Project	IEEE 802.16 Broadband Wireless Access Working Group < http://ieee802.org/16 >		
Title	Corrections for AAS Diversity-Map Scan in OFDMA PHY		
Date Submitted	2004-11-16		
Source(s)	Yuval Lomnitz, Hassan Yaghoobi	Intel Corp	yuval.lomnitz@intel.com , hassan.yaghoobi@intel.com
	Tal Kaitz, Ran Yaniv	Alvarion	tal.kaitz@alvarion.com , ran.yaniv@alvarion.com
	InSeok Hwang	Samsung	Is91.hwang@samsung.com
	Dave Pechner, Todd Chauvin , Doug Dahlby, Adam Kerr	ArrayComm Inc.	dpechner@arraycomm.com , dahlby@arraycomm.com , adam@arraycomm.com , chauvin@arraycomm.com
Re:	IEEE P802.16-REVd/D5		
Abstract	This contribution introduces corrections for support of AAS Diversity-Map Scan in the OFDMA PHY		
Purpose	Adopt into P802.16d/D5 corrigenda		
Notice	This document has been prepared to assist IEEE 802.16. It is offered as a basis for discussion and is not binding on the contributing individual(s) or organization(s). The material in this document is subject to change in form and content after further study. The contributor(s) reserve(s) the right to add, amend or withdraw material contained herein.

Corrections for AAS Diversity-Map Scan in OFDMA PHY

[Replace figure 224 with the following]

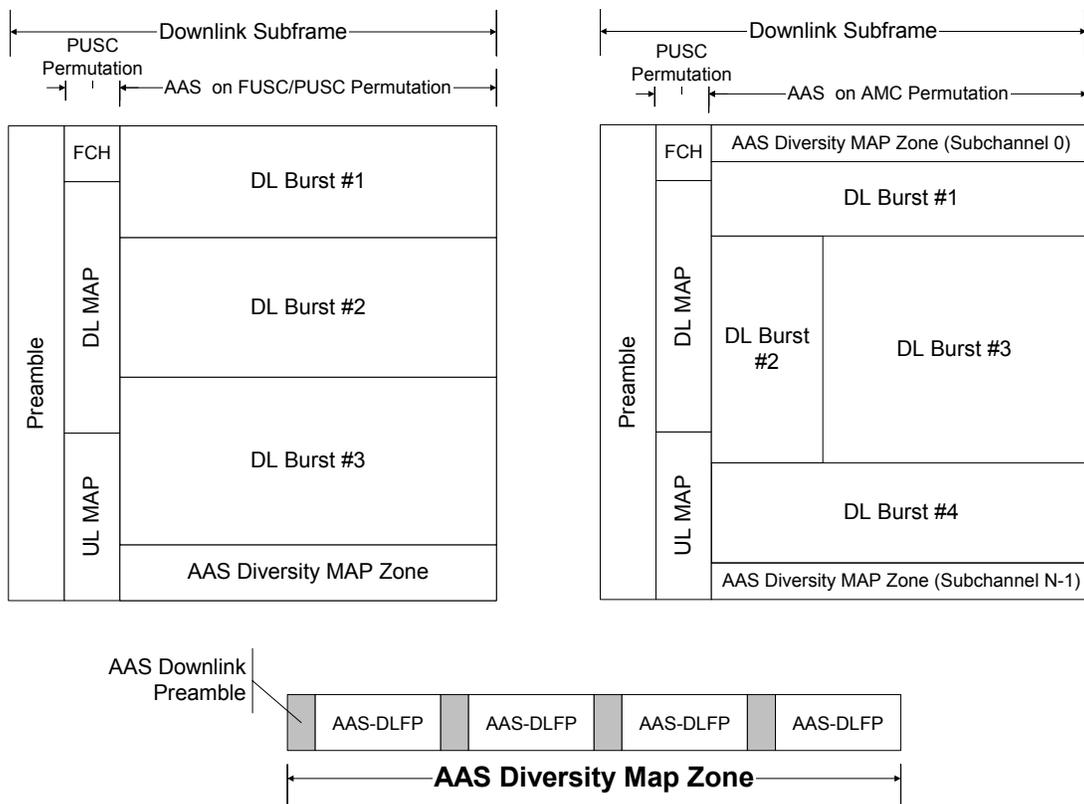
An AAS DL Zone begins on the specified symbol boundary and consists of all subchannels until the start of the next Zone or end of frame. The two highest numbered subchannels of an AAS DL Zone may be dedicated at the discretion of the BS for the AAS Diversity-Map Zone in the PUSC, FUSC and optional FUSC permutation. For the PUSC permutation, it is assumed that all AAS subscribers can decode the FCH in order to know the Used Subchannel Bitmap.

In the AMC permutation, the 4th and (N-4)th first and last subchannels of the total N subchannels of the AAS DL Zone may be dedicated at the discretion of the BS for the AAS Diversity-Map Zone. For AMC permutation, each subchannel for the AAS diversity MAP consists of 3 bins by 2 bins by 3 symbols. A 2 bin by 3 symbol tile structure shall be used for all AMC permutations in an AAS zone.

When these subchannels are used for this purpose a Diversity-Map zone, they shall not be allocated in the normal DL-MAP message and shall be used only on the AAS portion of the DL sub-frame. These subchannels will be used to transmit the AAS-DLFP() whose physical construction is shown in Figure 223. In the case that the AAS Diversity-Map zone is not included in the AAS zone, these subchannels may be used for ordinary traffic and may be allocated in DL_MAP messages.
